**Consultations and Notification Responses**

11 November 2013  
Your Ref: 13/05799/FULEA  
My Ref: 13/05799/FULEA

**A hybrid planning application seeking detailed planning permission for the demolition of the existing buildings and mixed use development to provide 441 dwellings (362 houses and 79 apartments) 448.13m<sup>2</sup> retail unit (Class A1), 536.05m<sup>2</sup> community centre (Class D1), 211.55m<sup>2</sup> Air Training Corps building (Class D2), 9 industrial units (2819.29m<sup>2</sup> Class B1c/B8), bus hub, school drop-off, open space, play areas, landscaping, car parking, the creation of a new access from Daws Hill Lane, retention of the existing access from Daws Hill Lane. Outline planning application for a primary school and pre-school (up to 1350m<sup>2</sup> Class D1) with all matters other than access reserved**

**RAF Daws Hill Daws Hill Lane High Wycombe Buckinghamshire HP11 1PZ**

### **Daws Hill Lane/Commercial Site Access.**

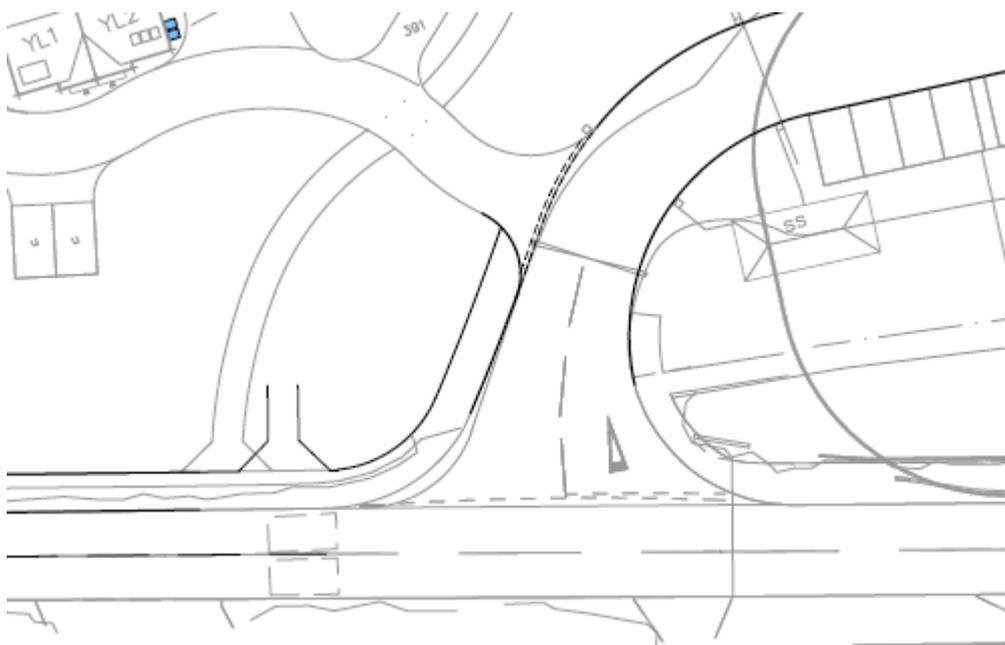
In addition to the main “lozenge” junction which serves the residential (and ancillary uses) element of the site, a second simple priority junction is retained to serve the relatively small amount of employment development also proposed. This is an existing simple priority junction which has no ghost island right turn lane facility and is located a short distance to the east of the main site access along Daws Hill Lane. An extract from drawing 25263/005/001 Rev B showing the junction arrangement is set out below for ease of reference.

With reference to my earlier explanation of the NPPF requirements and normal operating thresholds for a junction it can be seen that this junction operates well within capacity with minimal reported queuing.

### Increased Capacity for the Left Turn Movement from Daws Hill Lane to Marlow Hill

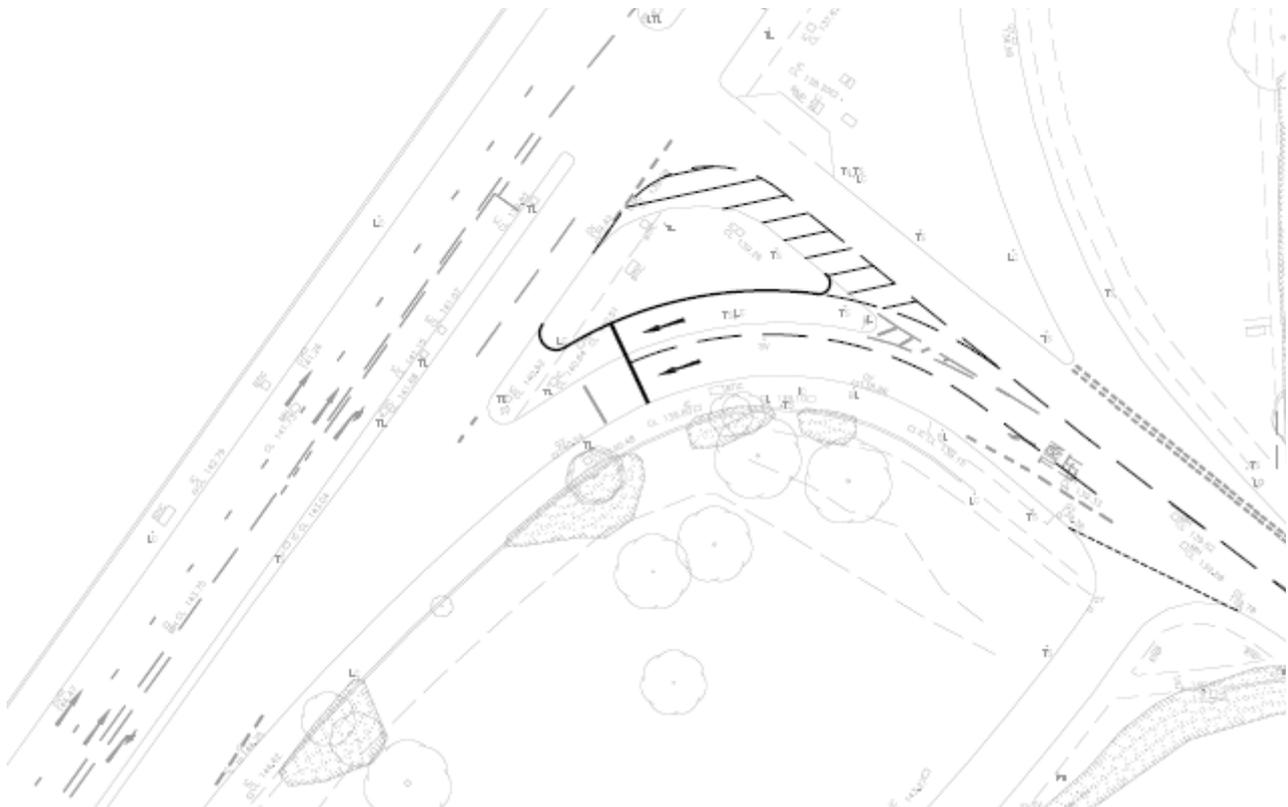
- 8.4.9. The exit from Daws Hill Lane onto Marlow Hill is currently 4.9m wide. Some vehicles use it as a two lane exit, however larger cars, vans, HGV's and less confident drivers use it as a single lane. The proposals are to widen the approach to 8m to allow all vehicles to use it as two lanes, therefore increasing capacity.

The improvements to the junctions are shown on drawing 25263/005/002 and an extract is shown below for ease of reference;

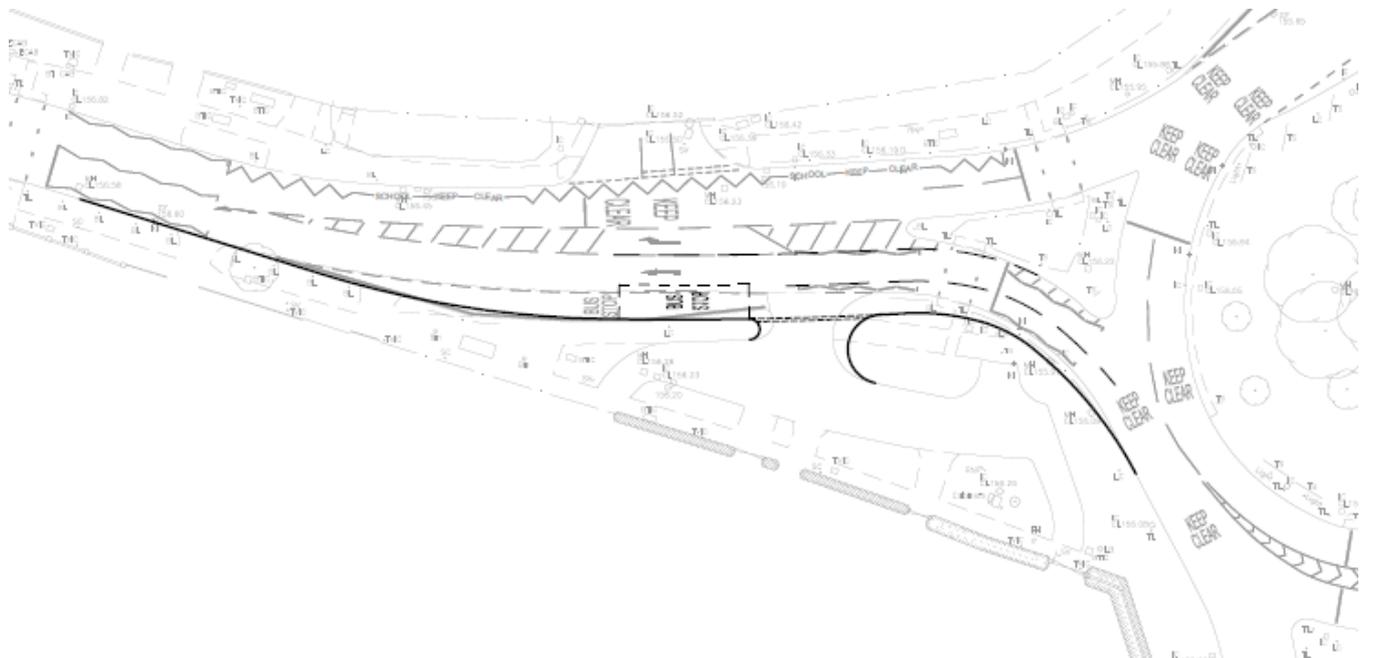
The capacity assessments have been updated to reflect these network changes and re-run. The results of the capacity assessments of the altered network are shown in Table 8.7 of the TA on page 63 and are as follows;

however some links where either degree of saturation or queuing increases. However, it is important to remember the test in paragraph 32 of NPPF in evaluating the results. Considering the red highlighted links in more detail indicates that the actual increases in delay and queuing are very small and could not in the Council's opinion be considered to represent a severe impact on the junction. The red highlighted areas typically show an increase in the number of vehicles in a queue of only 5 vehicles.

In summary the Council is satisfied that the mitigation works proposed to these junctions are sufficient to ensure that the development does not have a severe affect on their operation.

- Improvement to the Marlow Hill/Daws Hill Lane and Marlow Hill/Marlow Road junctions as shown in principle on drawing 25263/005/002;
- Improvements to the Heath End Road/Abbey Barn Lane junction as shown in principle on drawing 25263/005/005

**Abbey Barn Lane/Heath End Road.**

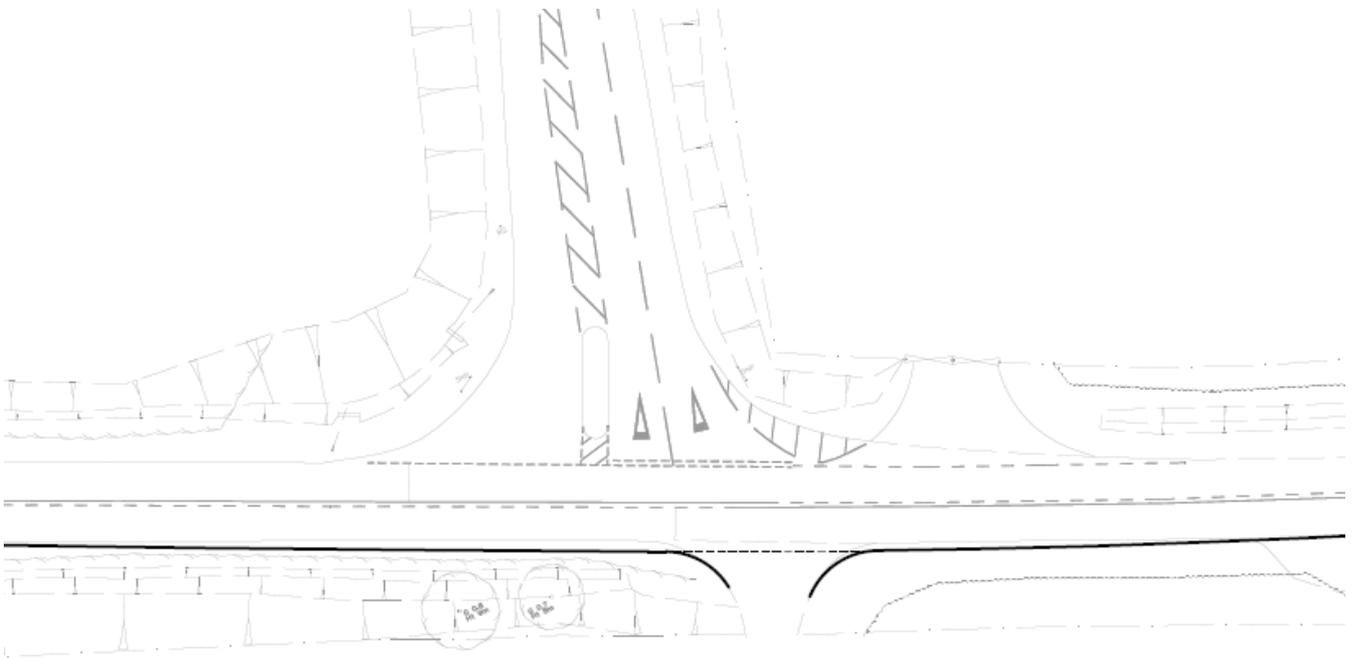
This junction takes the form of a simple priority junction and lies to the east of the site along Heath End Road. The operation of the junction is summarised with and without development in Table 8.9 on page 64 of the TA as follows;

It can be seen that whilst the improvement is questionable in real terms given the very limited change that it will have on the ground, the capacity analysis evidence base does suggest that it would offset the impact of development traffic if the results in Table 8.10 are compared to those set out in Table 8.9.

Rights of Way Plan

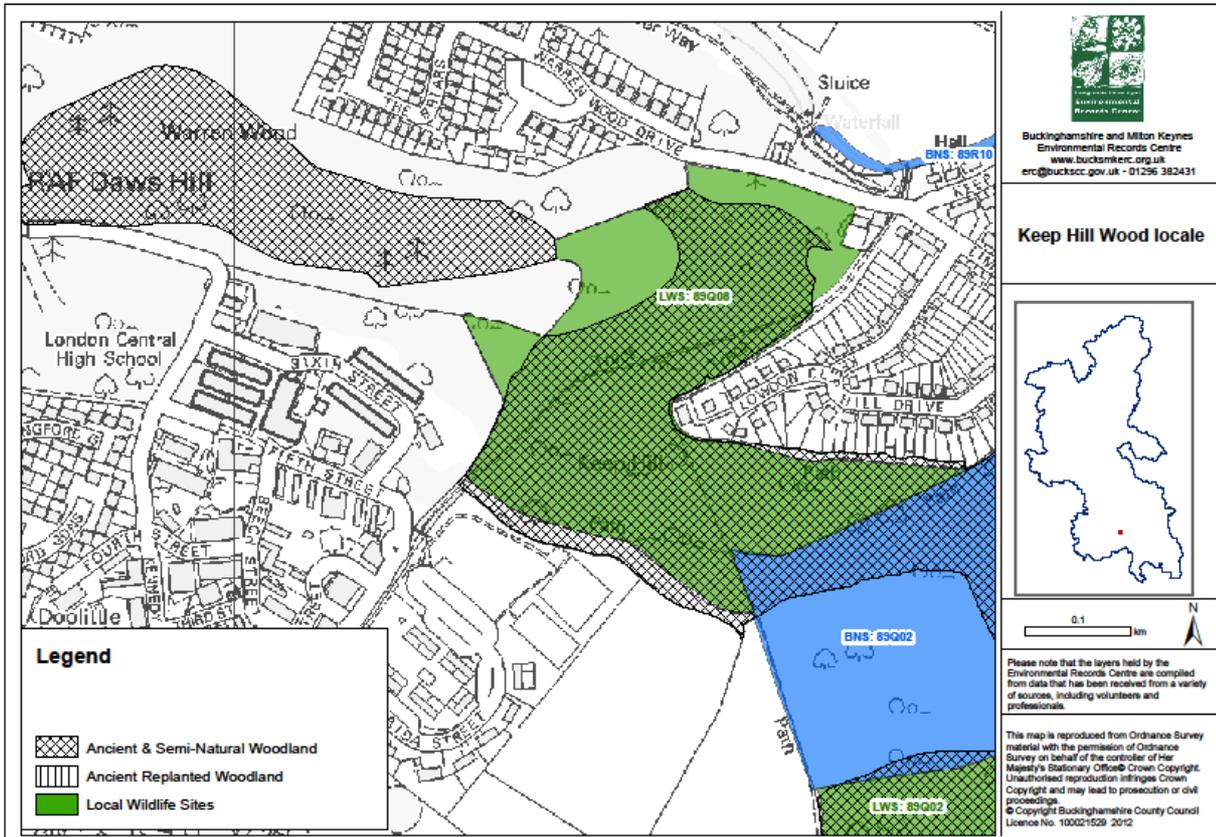
Key to improving this bridleway to be suitable for users with push chairs, mobility scooters, walkers and cyclists, is to upgrade the surface. In addition, it has been mooted, in discussions outside the application, to 'snake' the bridle path in order to reduce the steepest gradients. However, the woodland has sensitive and protected ecology and heritage designations so any proposal for a path that intends to alter ground conditions or remove trees in order to construct, would need permission from Natural England and English Heritage.

We would recommend any approval has a condition that improves this bridleway to provide a primary sustainable transport link to the Rye and town centre, details of which should be agreed at a later date. With regard to the 'zig-zag' route the integrity of the existing bridleway is not be compromised by construction of the new route.
